Office Action Summary	Application No. 10/528,369	Applicant(s) SAITOH ET AL.	
	Examiner Zachary Snyder	Art Unit 4135

DETAILED ACTION

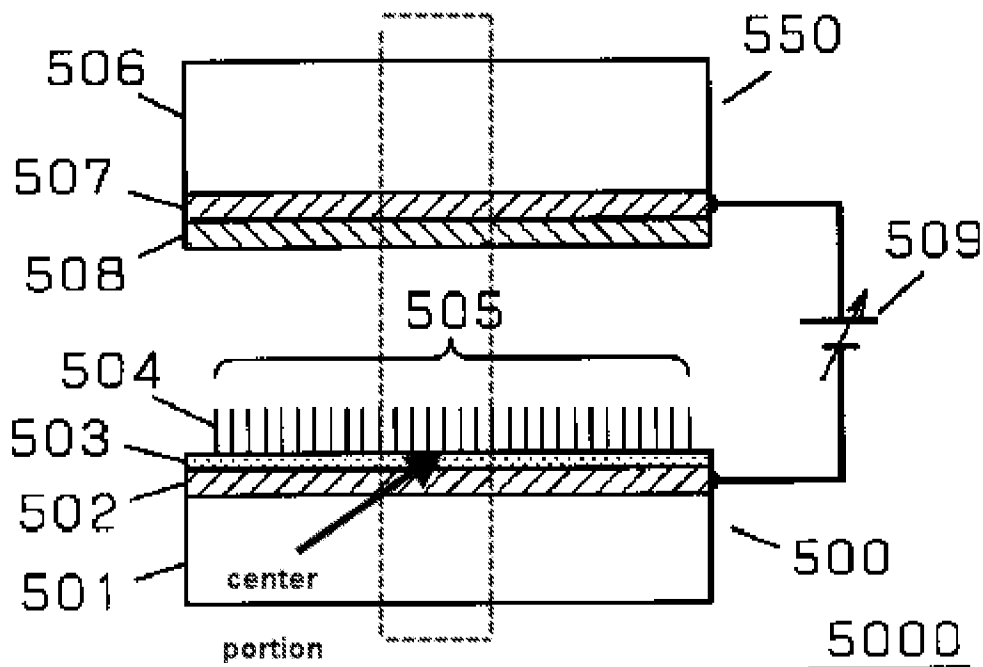
In regard to claim 14, Koji in view Hidetoshi teaches all the limitations of claim 11. Koji also discloses that the light emitting electrode (electron emission element 500) is disposed on an inner surface of the container (inherently held in a container) and the cold cathode (cold cathode 505) is disposed in a center portion of the container (shown below).
